International
Isotopes
INCORPORATED

Subject: Request to Amend Sealed Source and Device Registrations NR-1235-S-102-S, NR-1235-S-104-S, NR-1235-S-106-S, NR-1235-S-107-S, NR-1235-S-108-S, and NR-1235-S-109-S

The revised labels, and associated SSDR and Source Models are provided in the attached Label Revision table.

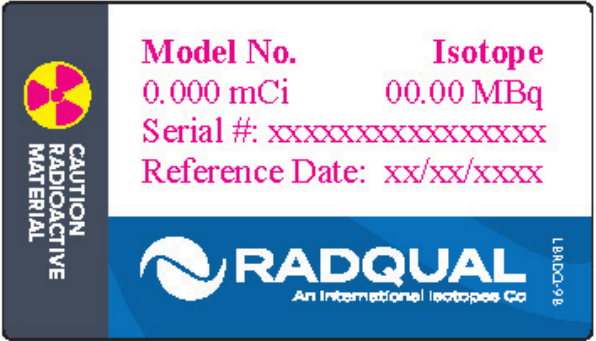
International Isotopes Inc. (INIS) is revising the logo for RadQual LLC, a wholly owned subsidiary of INIS, and intends to incorporate a new logo on sealed sources covered under Sealed Source and Device Registrations NR-1235-S-102-S, NR-1235-S-104-S, NR-1235-S-106-S, NR-1235-S-107-S, NR-1235-S-108-S, and NR-1235-S-109-S.

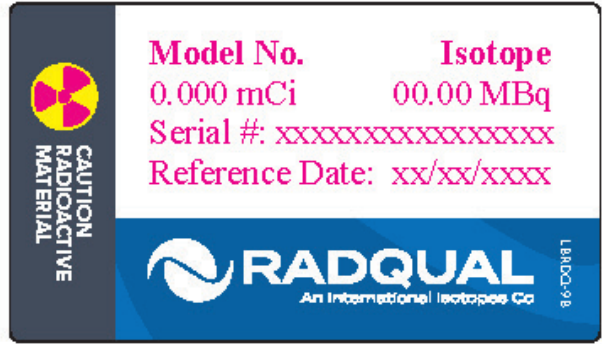
In addition, and to comply with US, EU, and UK medical device labeling requirements, the source or source packaging will include a unique identifier label (UDI), also referred to as a barcode, the Conformité Européenne Mark (CE), the UK Conformity Assessed Mark (UKCA), and the names and addresses of our authorized representatives for the European Union.

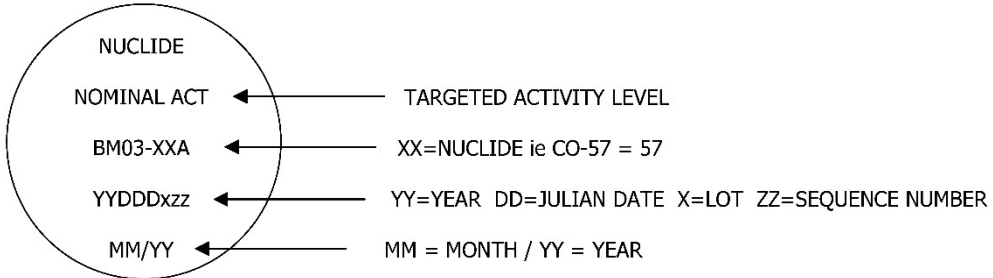
<p>NR-1235-S-104-S (Co57 Flood sources)</p>	<p>BM01L</p>	<div data-bbox="730 228 1791 1286"><p>The label is for a RADLITE Cobalt-57 Flood Source. It features the RADLITE logo with 'by RadQual' underneath. The model number is 00 mCi 000 MBq, and the serial number is xxxxxxxxxxxx. The reference date is xx/xx/xxxx, and the recommended replacement date is xx/xx/xxxx. A cautionary note states that the U.S. Nuclear Regulatory Commission has approved distribution of this source to persons licensed to use byproduct material identified in Title 10 Code of Federal Regulations Part §35.65 and to persons who hold an equivalent license issued by an Agreement State. The label also includes a barcode with the number 00850020470594, the CE UK CA mark, and contact information for the manufacturer, International Isotopes, Inc., and the EC REP, EuropeCert.</p></div> <p>Label: LBRDQ-1B, 5 in. x 5 in. (Note: EC REP and UK Responsible Person subject to change)</p>

Label: LBRDQ-12B, 5 in. x 5 in.

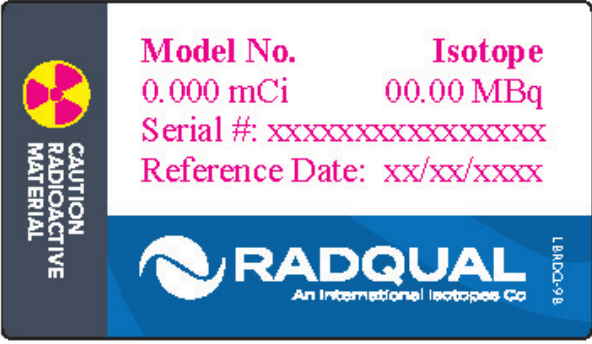
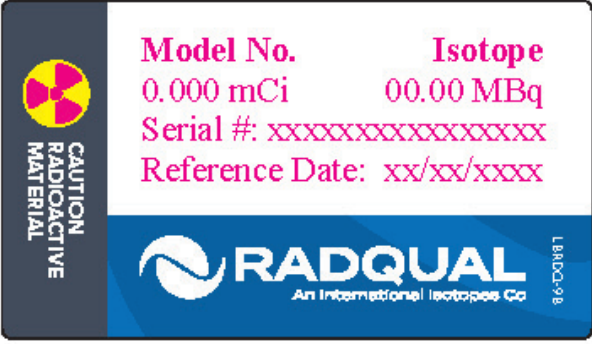
NR-1235-S-104-S (Co57 Flood sources)	BM01L (Jubilant)	<div data-bbox="764 224 1766 1227">   <p>Cobalt-57 Flood Source</p> <p>LBRDQ-12B</p> <div data-bbox="926 488 1604 786"> <p>Model No. 00 mCi 000 MBq</p> <p>Serial Number: xxxxxxxxxxxx</p> <p>Reference Date: xx/xx/xxxx</p> <p>Recommended Replacement Date: xx/xx/xxxx</p> </div> <div data-bbox="848 797 961 915">  </div> <p>CAUTION RADIOACTIVE MATERIAL</p> <p>See Use and Handling Instructions</p> <p><small>The U.S. Nuclear Regulatory Commission has approved distribution of this source to persons licensed to use byproduct material identified in Title 10 Code of Federal Regulations Part §35.65 and to persons who hold an equivalent license issued by an Agreement State.</small></p> <div data-bbox="789 1003 1745 1203"> <div data-bbox="806 1016 1052 1190">  <p>00850020470594 Model</p> </div> <div data-bbox="1087 1016 1346 1190"> <p>CE UK CA</p> <p>Manufactured and distributed by: International Isotopes, Inc. 4137 Commerce Circle Idaho Falls, Idaho, 83401 USA for Jubilant Radiopharma.</p> </div> <div data-bbox="1381 1016 1738 1190"> <p>EC REP, EU Authorized Representative: EuropeCert Alstraße 97, 41063 Mönchengladbach, Germany</p> <p>UK Responsible Person I3CGLOBAL(UK) Office 54, No:58, Peregrine Road, Hainault, Ilford, Essex, England. IG6 3SZ</p> </div> </div> </div>

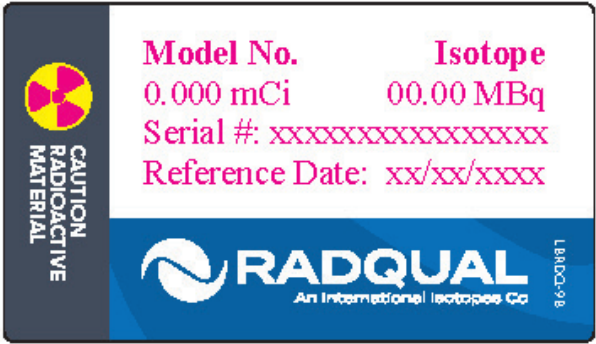
NR-1235-S-107-S (Rigid and Flexible, Line and Ruler sources)	BM83-10 BM83-20 BM83-30	<p>Sources with flexible tubing or rigid Acrylic as outer encapsulation</p>  <p>Lable: LBRDQ-9B, 1.75 in. x 1 in.</p>
	BM83-12 BMXX-YY	<p>Sources with stainless steel as outer encapsulation:</p> <p>Option 1: Laser etch with: Trifoil, Model Number, Isotope, Activity, Serial Number, and Reference Date (as size permits).</p>
		<p>Option 2:</p>  <p>Lable: LBRDQ-9B, 1.75 in. x 1 in. (Note this lable may be included on steel sources with partial etchings)</p>
